Access Compliance Report

Public Rights-of-Way

(Pedestrian Signals)

Intersection ID: N/A	Main Street:	Cross Street: N/A	Location: N/A
ADA ID: 9C75A1A8B7DD	Signal Type: One Push Button-Non APS	Overall Compliance: No	Severity Score: BTN 1: N/A BTN 2: N/A No BTN: N/A
Codes/Mitigation Info/Possible Solution		Field Measurements/Component Compliance

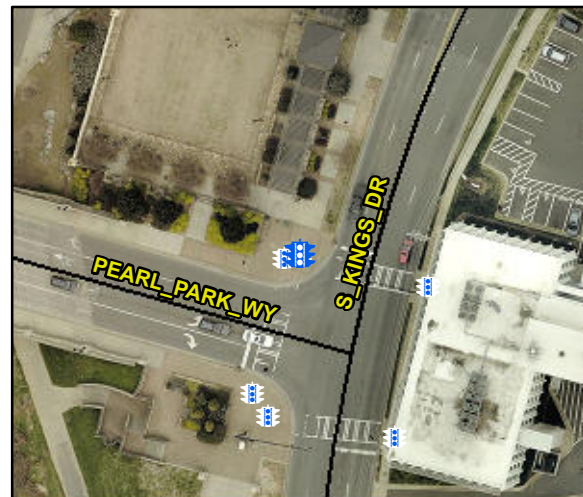
Possible Solutions: Replace Signal Push Button With APS Button on New Post. Remove & Relocate Sign.

PROW/ADA: TMUTCD 4e.08, R404.2

N/A	B 1 Clear Xing Direction?	N/A	N/A	B 2 Clear Xing Direction?	N/A
	B 1 Crossing Direction	To E		B 2 Crossing Direction	N/A
Yes	B 1 DistanceTo XWalk (in)	0.0	N/A	B 2 DistanceTo XWalk (in)	N/A
No	B 1 DistanceTo Curb (in)	141.0	N/A	B 2 DistanceTo Curb (in)	N/A
Yes	B 1 Diameter (in)	2.0	N/A	B 2 Diameter (in)	N/A
